New York State Department of Environmental Conservation 73800

## MEMORANDUM

TO: Mr. Charles Branagh, P.E. - Region 7 FROM: Mr. Raymond E. Lupe, P.E. - Bureau of Hazardous Site Control-Volney Silk Road Landfill - Oswego County SUBJECT:

I have reviewed the reports entitled "Engineering Report for the Closure of the Oswego Valley Sanitary Landfill", prepared by Barton and Loguidice; and "Evaluation of Hydrogeologic Conditions and Preparation of A Ground Water Monitoring Program, Oswego Valley Landfill", prepared by Geraghty and Miller, Inc.

FIGURE 7 - LOCATIONS OF PROPOSED MONITORING WELLS AND SURFACE-WATER STATIONS, Oswego County Landfill; Oswego County, New York.

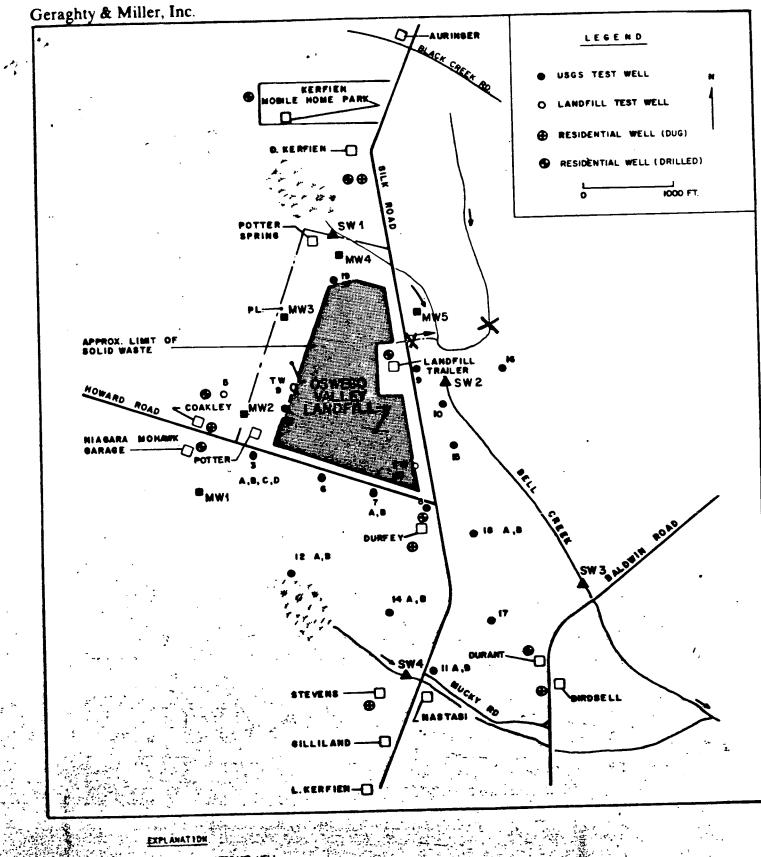
- 5. The analyses to be performed in the surface water monitoring program were not listed. Both sediment and water column samples should be collected and analyzed. In addition, two additional sampling locations are recommended as shown on the attached figure.

- PROPOSED NONITORING WELL PROPOSED SURFACE-WATER STATION
- Recommanced Additions to Proposed Qp X Sampling (NYSDEC Review, BCT. 1984)
